## **Report to Development Permit Panel**

DP 22-017484

Application by Polygon Talisman Park Ltd. for a Development Permit at

3588 Ketcheson Road

5 PICKET GATE
1. = 1.-0.

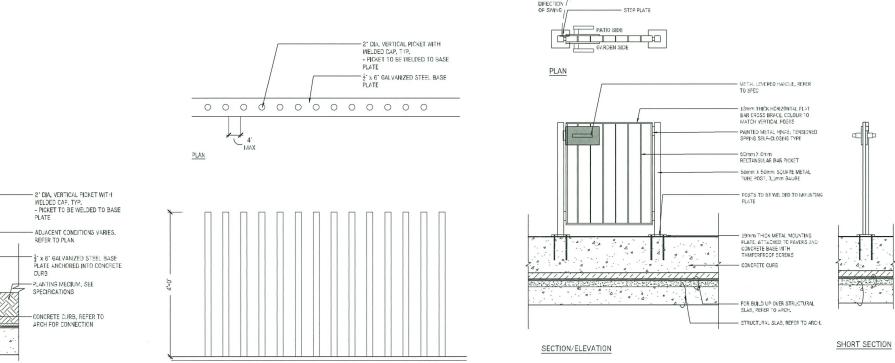
- consider enhancing the design of the picket fences in front of the units along the south side to make them more artsy, colourful and interesting in order to provide more visual appeal to passing pedestrians and in keeping with its location in the Richmond Arts District Design improved. Guardrail has been updated to include coloured vertical slats that extend the abstract marsh grass motif to the ground level patios. The colour scheme utilizes the building colour palette;
